Addendum / Addenda

Project Description / Description de projet U66 Chiller Replacement.		
Solicitation No./N° de sollicitation 16-22146	Project No./N° de projet 5201	W.O. No./N° d'ordre de travail A1-006954-06-01
Departmental Representative / représentant ministériel Maurice Richard		Date February 20, 2017
<p>Notice: This addendum shall form part of the tender documents and all conditions shall apply and be read in conjunction with the original plans and specifications.</p>		<p>Nota: Cet addenda fait partie intégrale des dossiers d'appel; toutes les conditions énoncées doivent être lues et appliquées en conjonction avec les plans et les devis originaux.</p>

NRC Chiller and HVAC replacement at U-66

Addendum #2

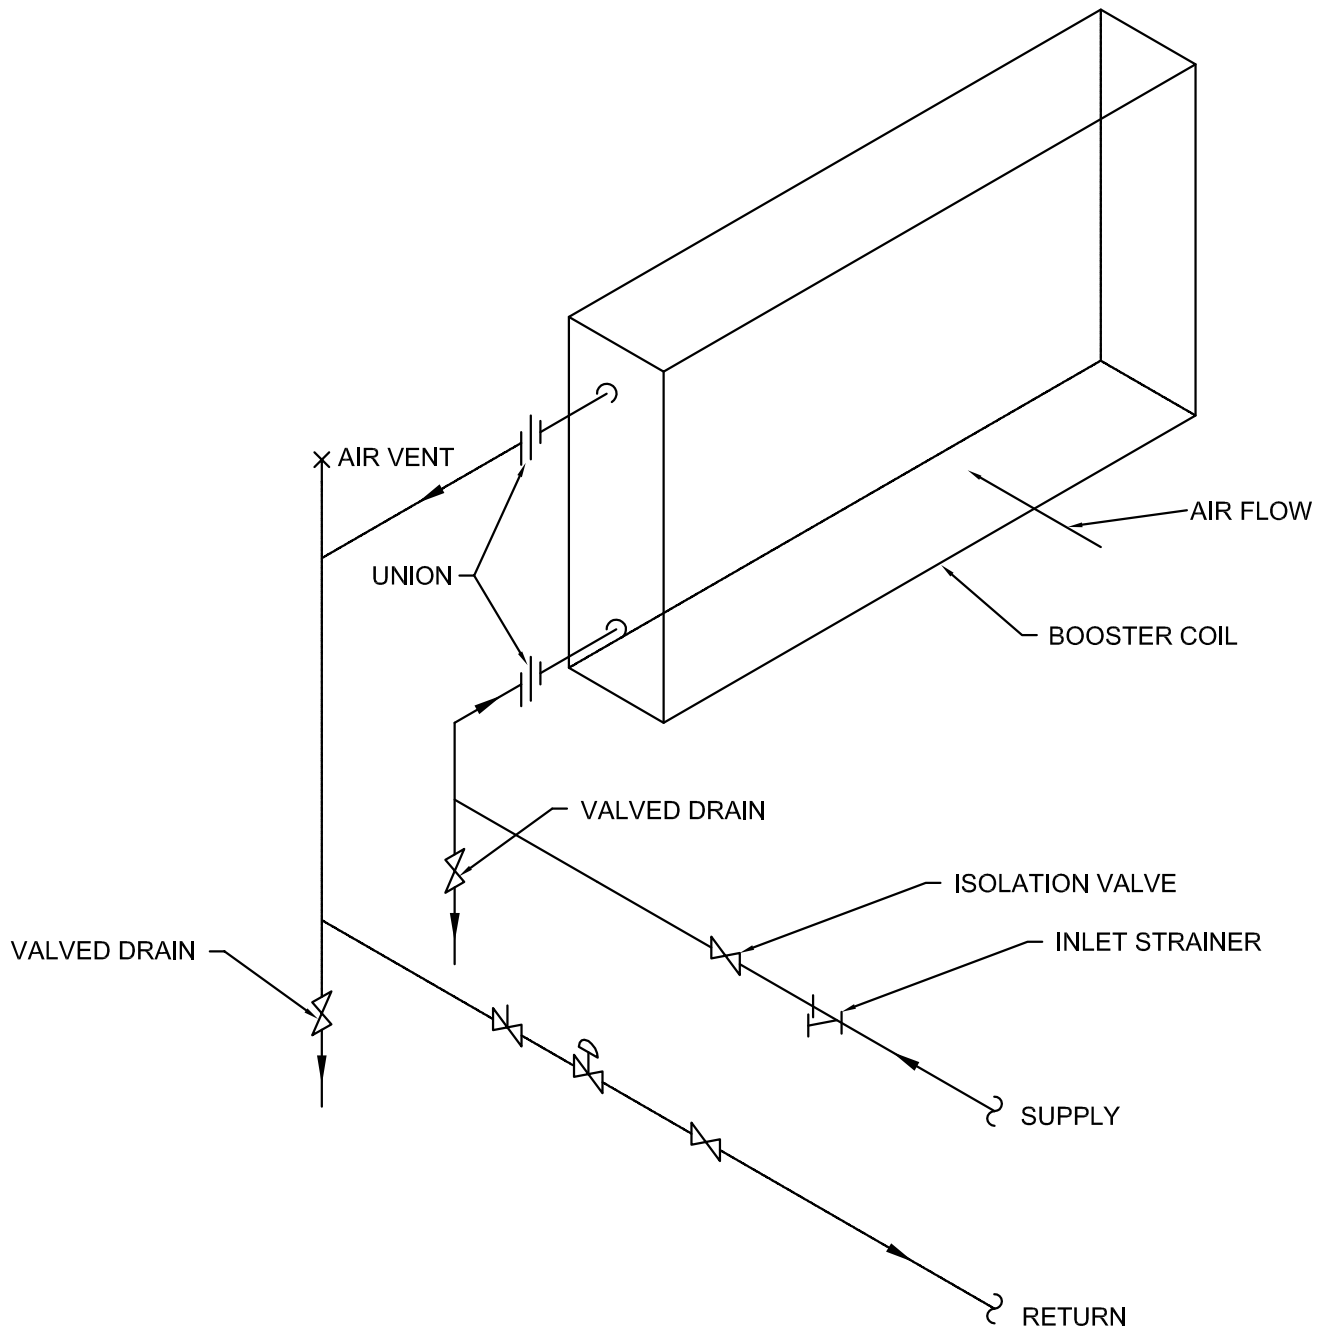
- b. Provide new heating water supply and return piping to feed the new heating coil in the new AHU. Provide a new isolation valves at the branch connection and heating control valve and hydronic specialties per the detail (typical coil detail attached) at the unit. Connect new piping to existing unit heater, complete with all hydronic specialties.

- ① ARRANGE PIPING & INSTALLATION OF VALVES SUCH THAT VALVES ARE GROUPED FOR EASY MAINTENANCE.
- ② SUPPORT DUCTWORK ON EACH SIDE OF THE BOOSTER COIL.
- ③ PROVIDE ACCESS DOOR IN DUCT UPSTREAM OF COIL FOR CLEANING PURPOSES.

Typical photos of existing perimeter heating & pneumatic control valves:

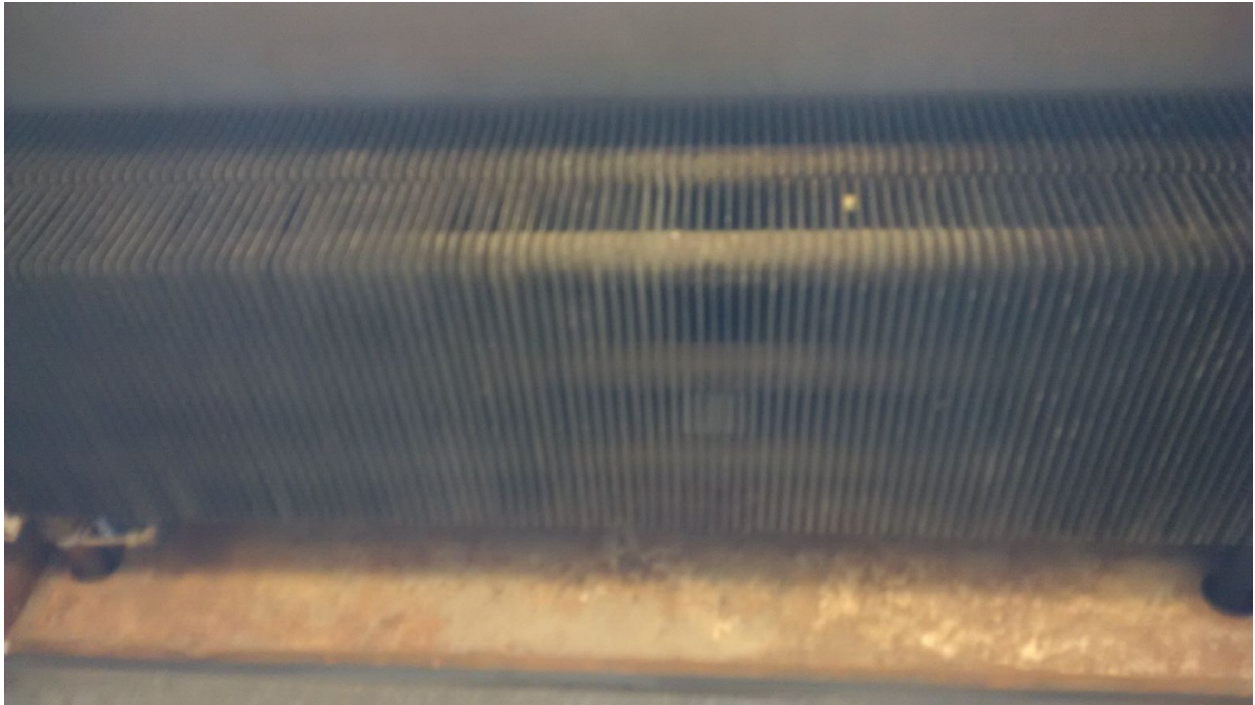
- 6** Add the following perimeter heating control valve work to the scope of work:
- a. The existing pneumatic control valves are to be demolished at each perimeter heating unit located on the 2nd floor within the area of work. Reconnect rads to heating water supply. These are located in the following rooms: 221, 225, 229, 230, 232, 233, 237, 238, 241, 242, 267, 268, 271, 272, 275, 276, 279.

- b. The existing pneumatic tubing is to be demolished back to the nearest main line.
 - c. A new DDC temperature sensor and DDC hydronic control valve will be provided for each new perimeter heating unit (provided by Airtron), the contractor is to allow for installation of the temperature sensor and the control valve. New hydronic heating control valves are to be located in the ceiling space of the floor below. Contractor to allow for scaffolding as required.

- f. Patching and painting to be included in contractor’s scope.
 - g. Refer to attached photos showing typical existing pneumatic control valves within perimeter heating unit and heating water supply pipes in the ceiling below.

- h. Total quantity of control valves is 19.
- 7** Refer to attached typical photos of existing perimeter heating control valves and the ceiling spaces below.
